Access Compliance Report

Public Rights-of-Way

(Curb Ramps)

Intersection ID: 18756	Main Street: RIGSBY_RD	Cross Street: STEELE_CREEK_RD	Location: W
ADA ID: F55767531CA1	Ramp Type: PerpDiag	Initial Pass/Fail: Fail	Overall Compliance: No
Severity Score: 12.5			
Codes/Mitigation Info/Possible Solution		Field Measurements/Component Compliance

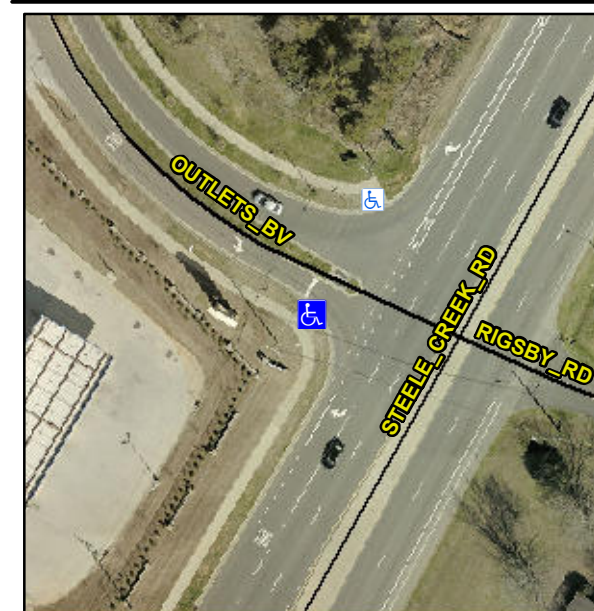
Not Found, R304.5.3

Compliance	Description	Data	Compliance	Description	Data
N/A	Ramp Length (in)	100.0	Yes	Ramp Slope (%)	7.0
Yes	Ramp Width (in)	48.0	No	Ramp XSlope (%)	5.5
N/A	Flare Type LT	N/A	N/A	Flare Type RT	N/A
N/A	Flare Slope LT (%)	N/A	N/A	Flare Slope RT (%)	N/A
N/A	Flare Traversable LT?	N/A	N/A	Flare Traversable RT?	N/A
N/A	Landing Length (in)	N/A	N/A	DWS Provided?	N/A
N/A	Landing Width (in)	N/A	N/A	DWS Contrast?	N/A
N/A	Landing Slope (%)	N/A	N/A	DWS Length (in)	N/A
N/A	Landing X Slope (%)	N/A	N/A	DWS Full Width?	N/A
N/A	Landing Curb? (Y/N)	N/A	N/A	DWS Offset (in)	N/A
N/A	Shared Landing?	N/A			
N/A	Gutter Ponding?	N/A	N/A	Gutter Slope (%)	N/A
N/A	Gutter Lip Ht (in)	N/A	N/A	Gutter X Slope (%)	N/A
N/A	Painted X Walk1?	No	N/A	Painted X Walk2?	No
	X Walk 1 Direction	To SE		X Walk 2 Direction	To NE
N/A	X Walk 1 Width (in)	N/A	N/A	X Walk 2 Width (in)	N/A
	X Walk 1 Slope (%)	5.8		X Walk 2 Slope (%)	7.0
	X Walk 1 X Slope (%)	6.3		X Walk 2 X Slope (%)	1.6

N/A	Ramp inside XWalk1?	N/A	N/A	Ramp inside XWalk2?	N/A
	Road Slope (%)	1.5	N/A	Clear Space?	N/A
	Road X Slope (%)	7.0	N/A	Clear Space to XWalk (in)	N/A
N/A	Any Obstructions?	N/A	N/A	Storm Grate/Utility Hazard?	N/A
	Obstruction Type			Storm Grate/Utility Type	
		N/A			N/A
			Yes	Surface Condition? (G/P)	Good

Remove & Replace Curb Ramp With Two New Directional Ramps or Equivalent.
